Part 2 Surrebuttal Testimony of Dr. Clyde Thomas Williams

A. Seismic Engineering and Design

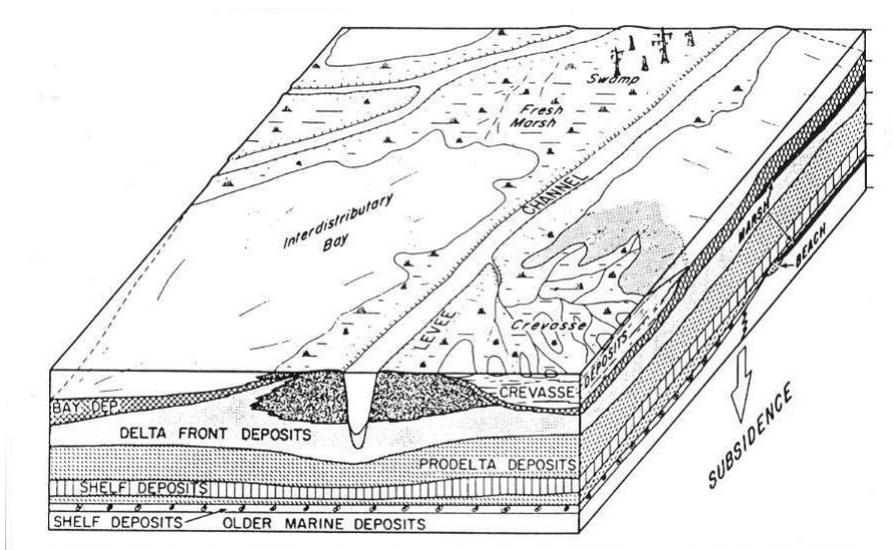
In addition, if one looks at the river crossings and Delta channel crossings in the above table, one finds that almost all of the river channels have undrained shear strengths of 1,000 psf or less. These range from 425 psf at Potato Slough (south of Bouldin Island) to 1000 psf at Old River. These soil samples would be classified as soft to firm under Terzaghi’s categories. The single exception is the San Joaquin River channel (DCRA-DH-012), which has undrained shear strength of 1,400 cfs, and would be classified as stiff. None of the river or channel crossing samples could be characterized as very stiff.

In sum, DWR's own boring data shows not only that the Delta alluvial deposits at the depths of the tunnels are NOT Class B or C, they may not even be Class D.

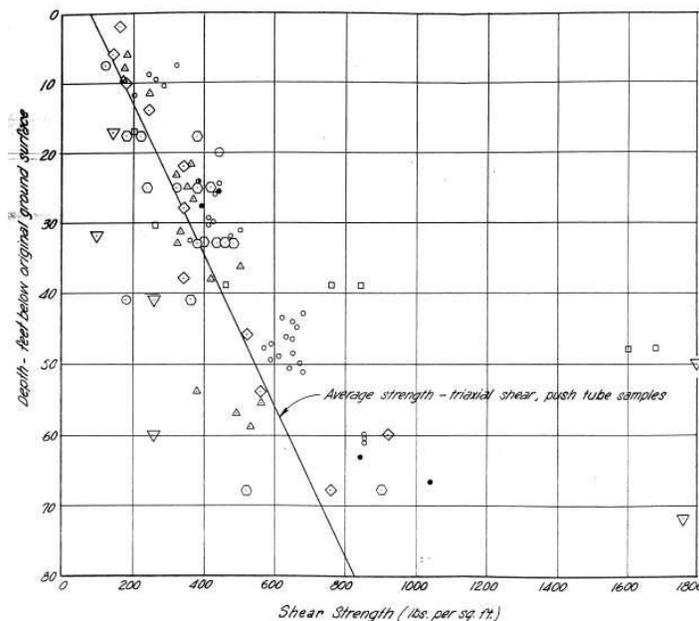
It is not unexpected that softer Holocene deposits would be deeper under Delta channels than under Delta Islands. The following diagram, from a powerpoint presentation by David Rogers and Rune Storesund on the Geologic Setting for the Sacramento San-Joaquin Delta², shows the geology of a natural Delta channel.

Chapter 4 also recognizes that bedrock is generally deeper than 1,000 feet in the project area. But it incorrectly classifies the soils at depths below 60 feet as “very stiff to hard,” stating

But in general, this description that the consolidated Pleistocene alluvium begins at 60 feet depths in the Delta appears incorrect. Geotechnical data shows that Delta alluvial deposits are much softer at 60 feet than “very stiff to hard.” The graph below, from the powerpoint on the Geologic Setting for the Sacramento San-Joaquin Delta, shows data from triaxial shear strength tests in the Delta. The tests show that, on average, soft Holocene deposits in the Delta become firm at around 60 feet, but only become stiff at much depths greater than 80 feet.

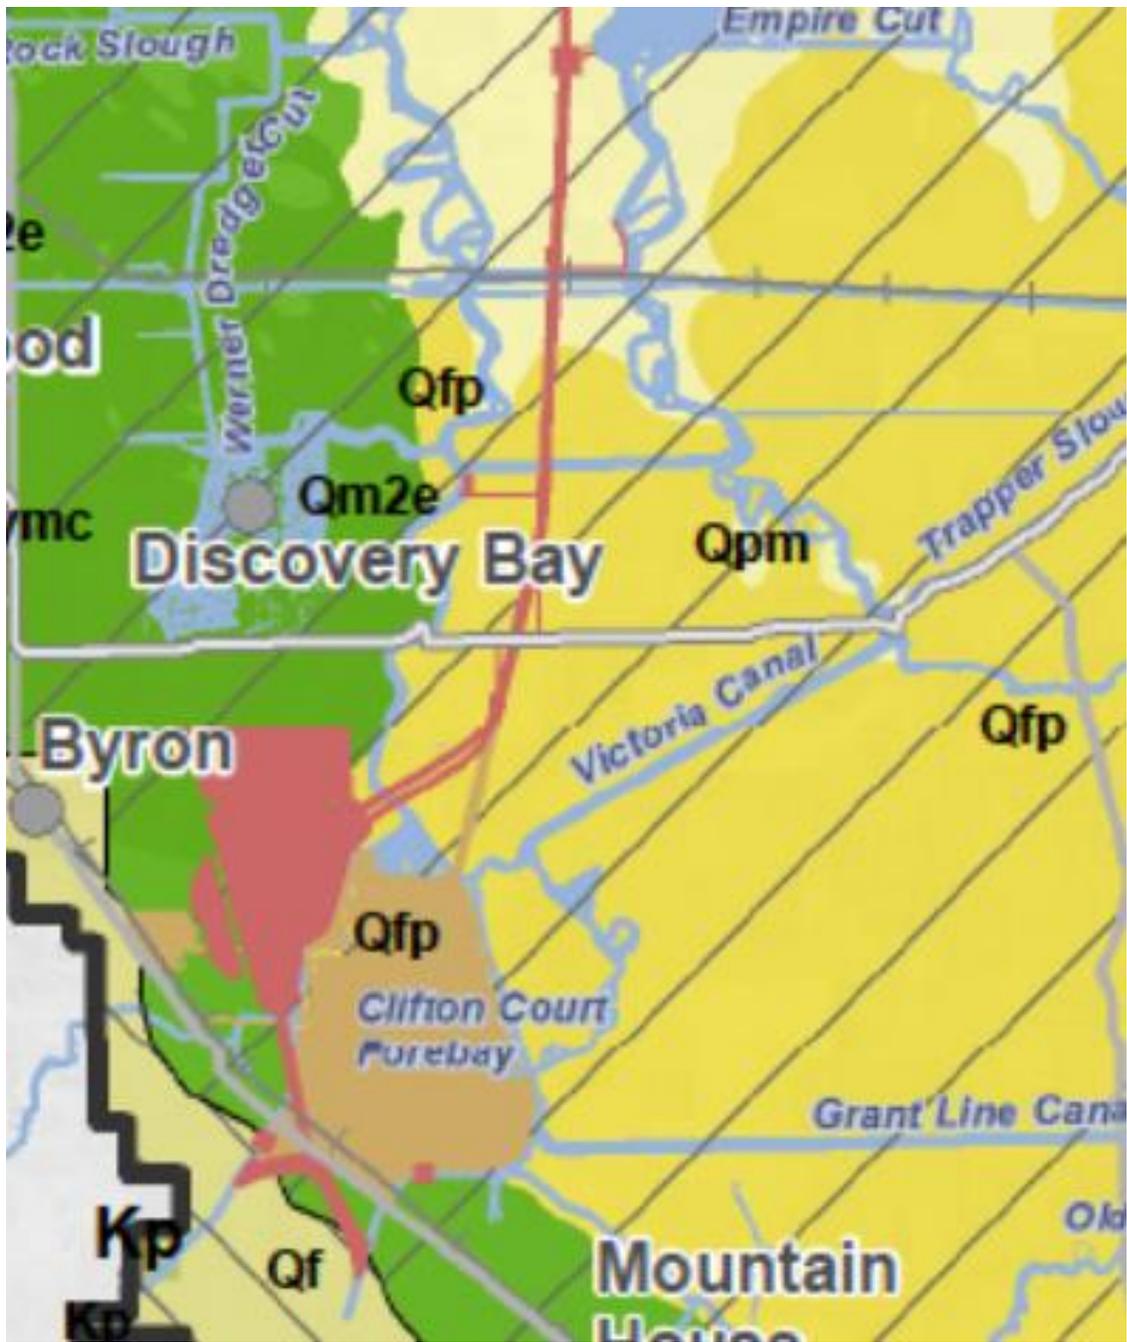
But an examination of the soil map on the first page in the Section 17, Paleontology Figures shows that many of the soils in the Central Delta are peat and muck (Qpm) or dredge spoils (Qds), which are not suitable for borrow material. Below are two closeups of the map on the first page, showing that much of the soils are Qpm or Qds.

Figure 7-50 from the Chapter 7 of the Delta Risk Management Strategy Risk Analysis Report.

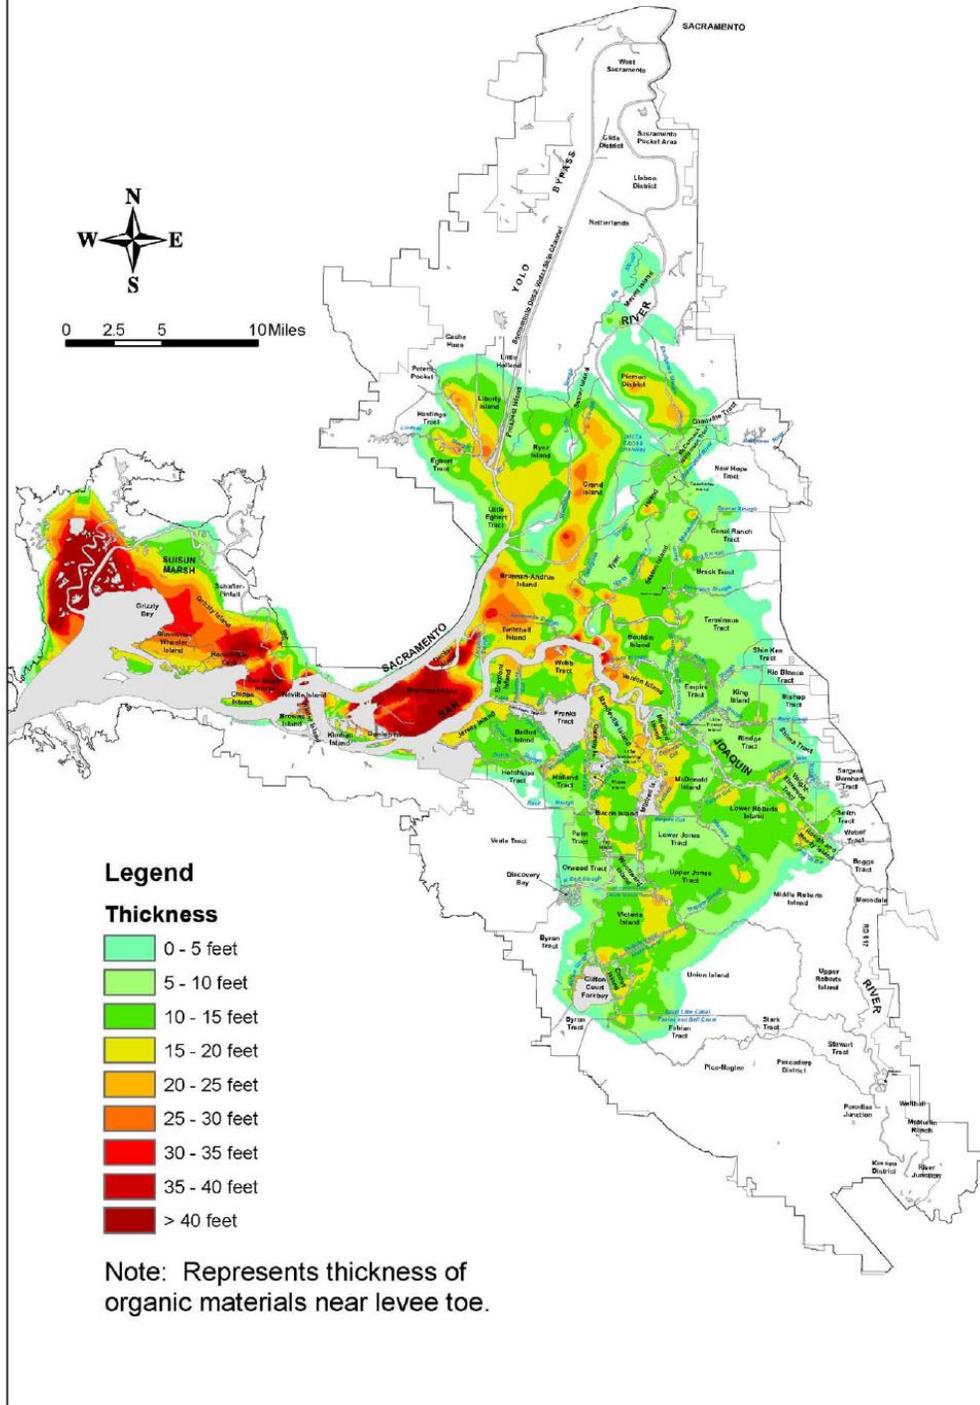
The map on the following page is from the Delta Risk Management Strategy Risk Analysis Report, and the second map is from the California Department of Water Resources' 1995 Delta Atlas³. Both maps show thick Delta soils.

Fig. 2. Dry bulk density, loss on ignition, and Pb, Hg, and Ti concentrations in the BRI core. Land surface is at 0.51 m MSL.

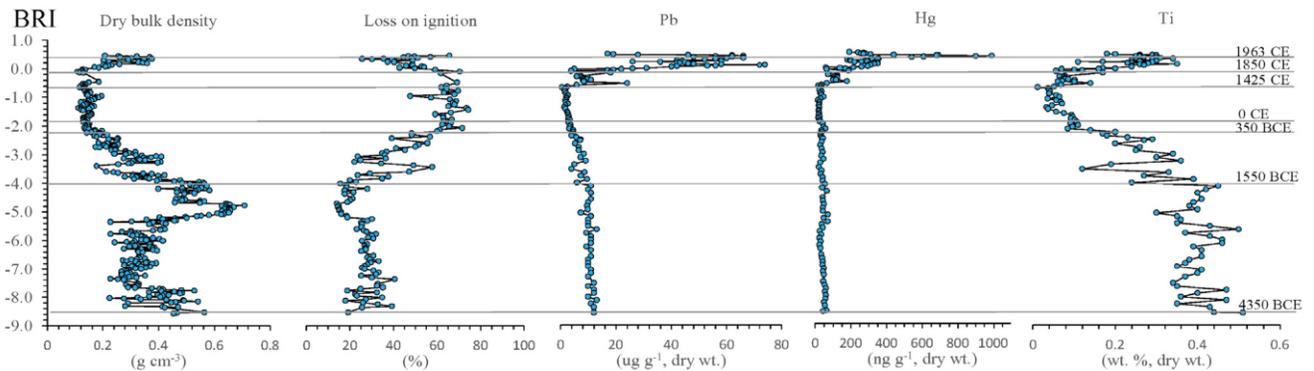
A study by Drexler et. al. for the US Geological Survey of lead (Pb), mercury (Hg), and Titanium in Delta peat wetlands⁵ found high concentrations near the surface, associated with the gold rush. The following map, from Drexler et. al., is from Browns Island:

There might be similarly high levels of lead and mercury in Delta Island soils dating back to the gold rush.

Fig. 3. Dry bulk density, loss on ignition, and Pb, Hg, and Ti concentrations in the FW core. Land surface is at 0.27 m MSL.

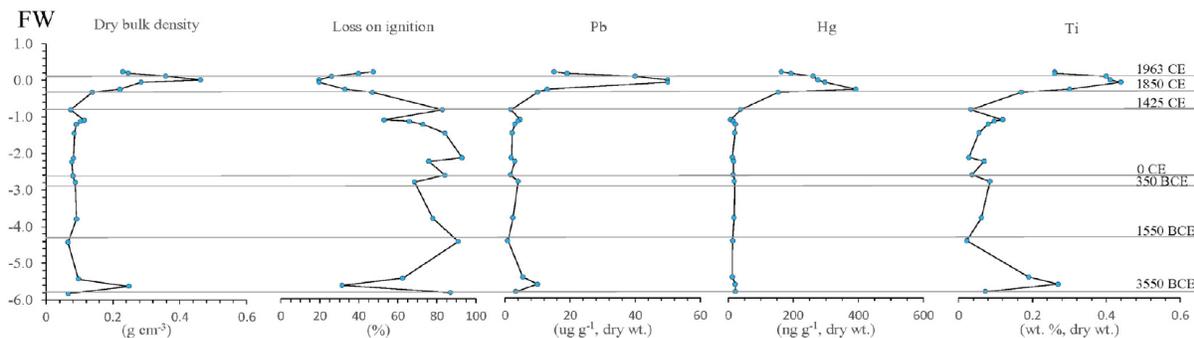
The following map, from Drexler et. al. is from Franks Wetland:

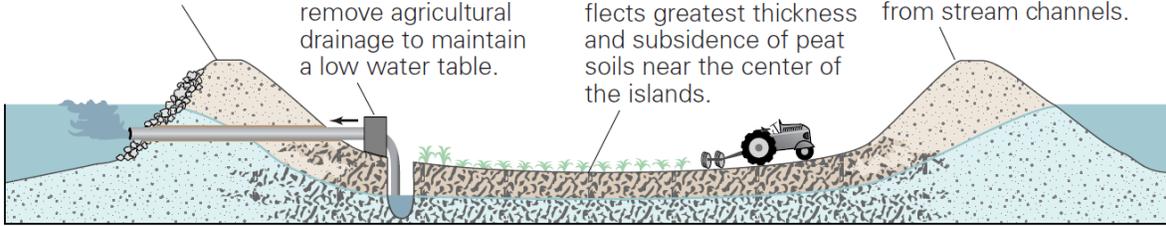
Once the RTM is wet and in contact with groundwater, the semicontinuous discharge pumps from the Delta islands would discharge the water from the RTM piles into the Delta channels, as shown in the figure below.⁶⁶

Figure 1 Distribution of percent soil organic matter in the Sacramento-San Joaquin Delta

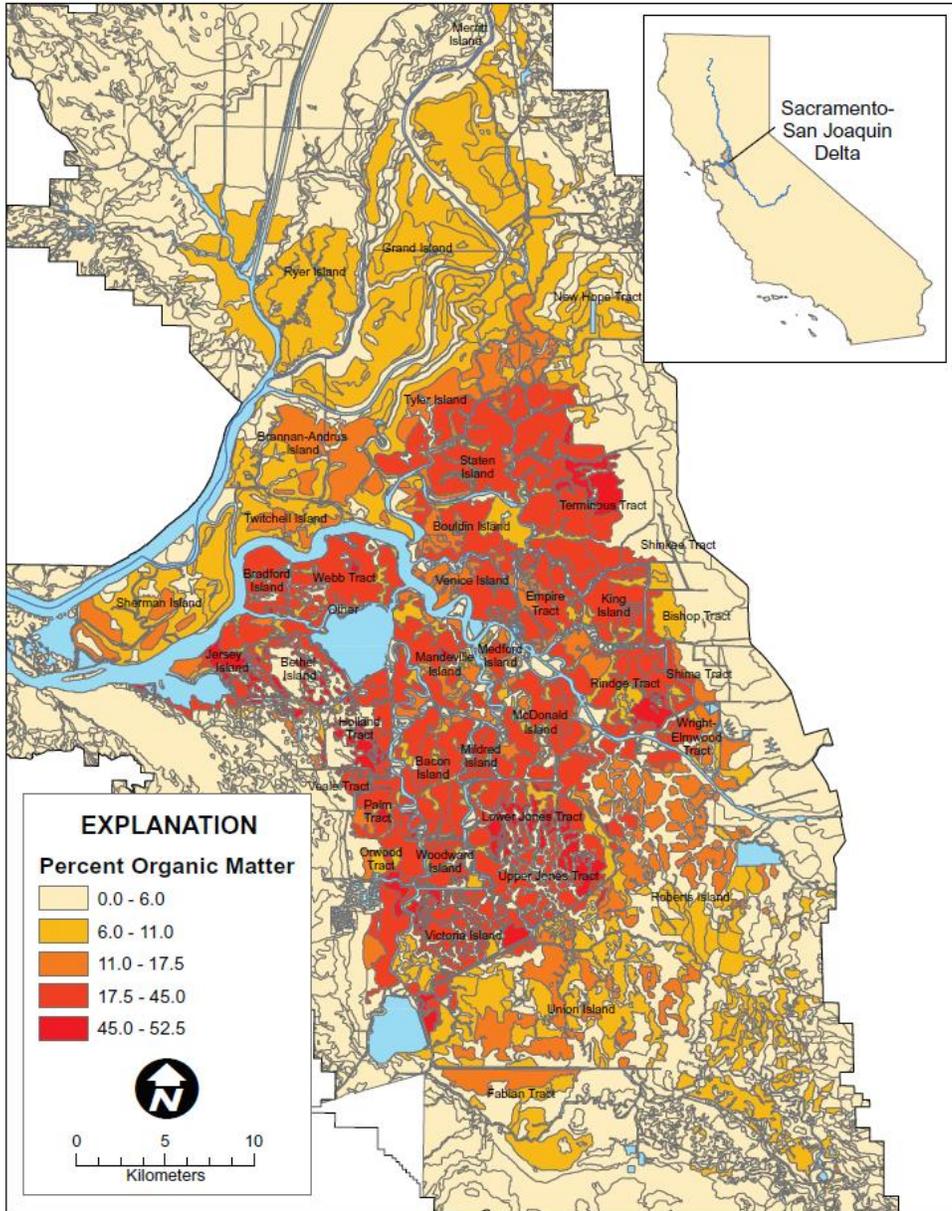
The Deverel and Leighton map is consistent with significant risks from near-surface soils.

Admin Draft Supplemental EIR/EIS, closeup of Figure 10-2, Organic Matter in Near-Surface Soils

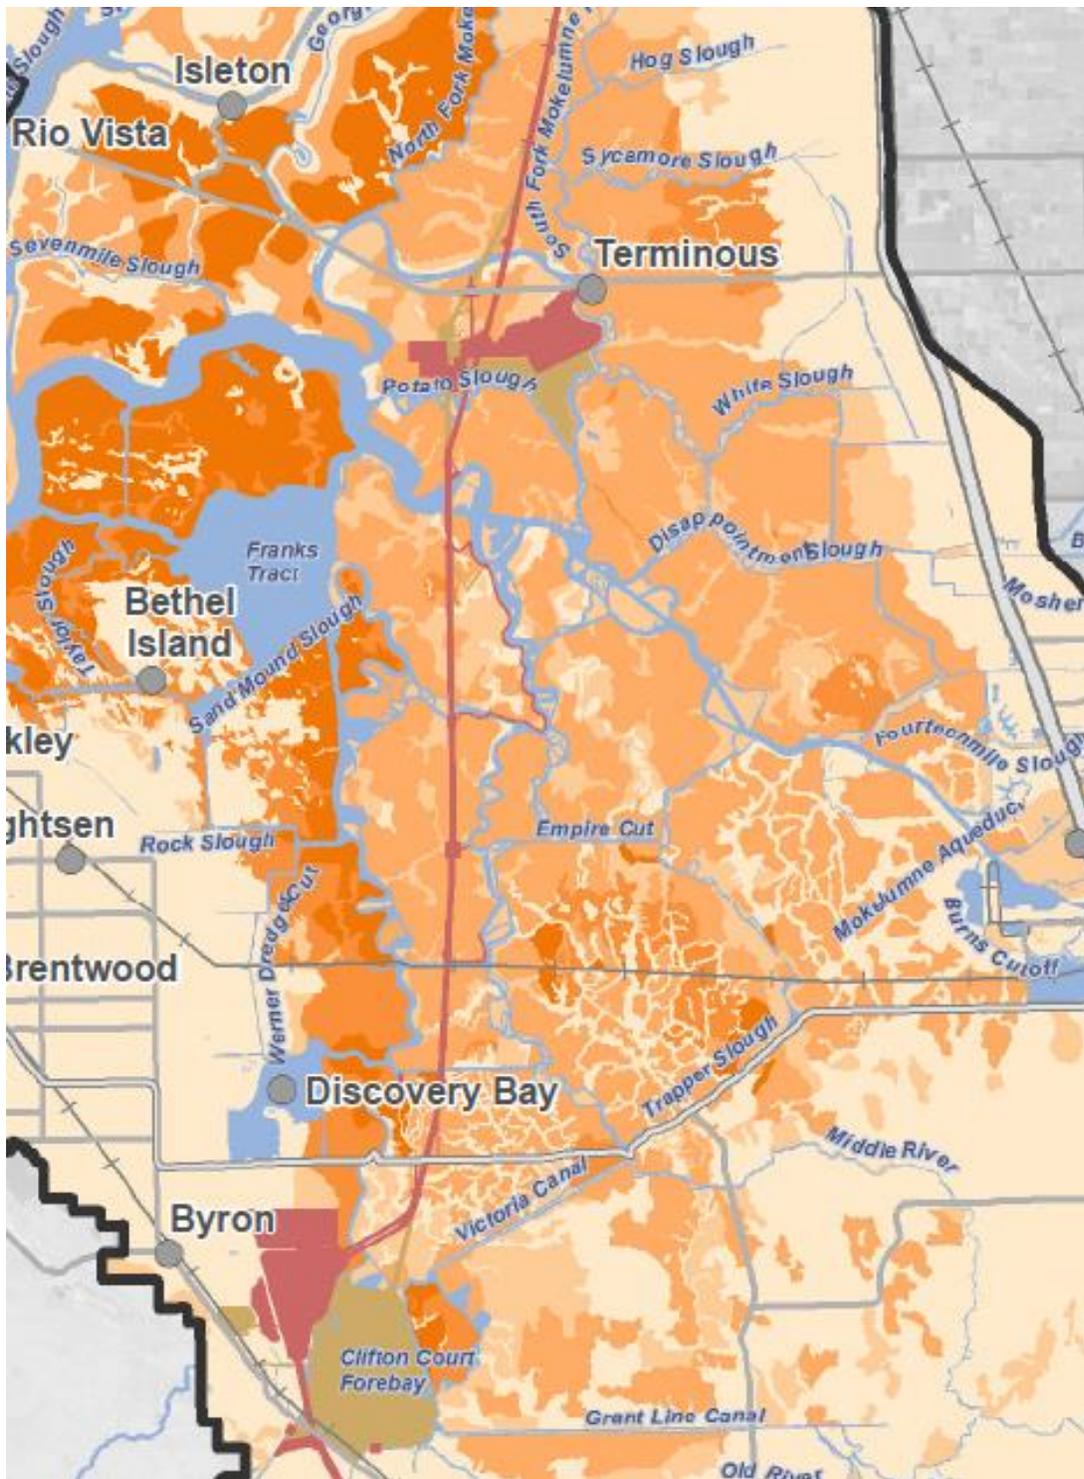
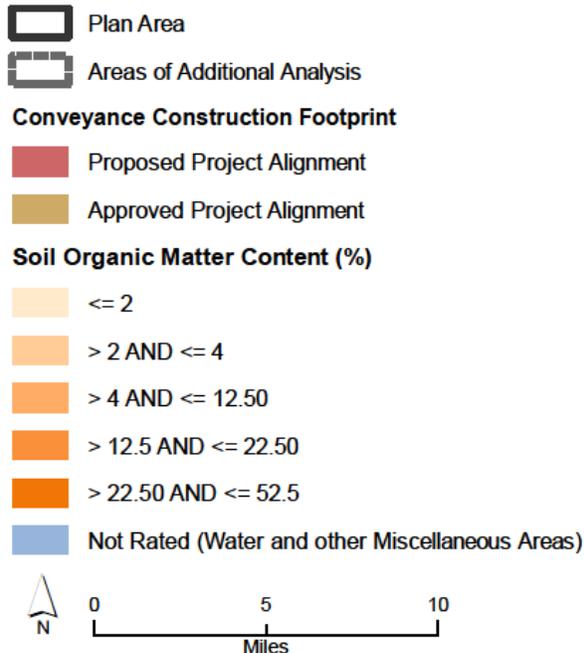
However, the geotechnical tests appear to refer only to the Reusable Tunnel Material Testing Report by URS, Exhibit DWR-207. The RTM soil samples are from significant depths. There are no tests of soils from the surface and near-surface layers. Published studies show very high levels of organic materials in surface and near-surface soils in the Delta, consistent with their known peat content. The map on the following page is Figure 1 from Deverel and Leighton, 2010.⁷ The maps of percent of organic matter in the Admin Draft Supplemental EIR/EIS, derived from the project’s Constructibility Report, show percentages roughly half that of peer-reviewed geologic studies.
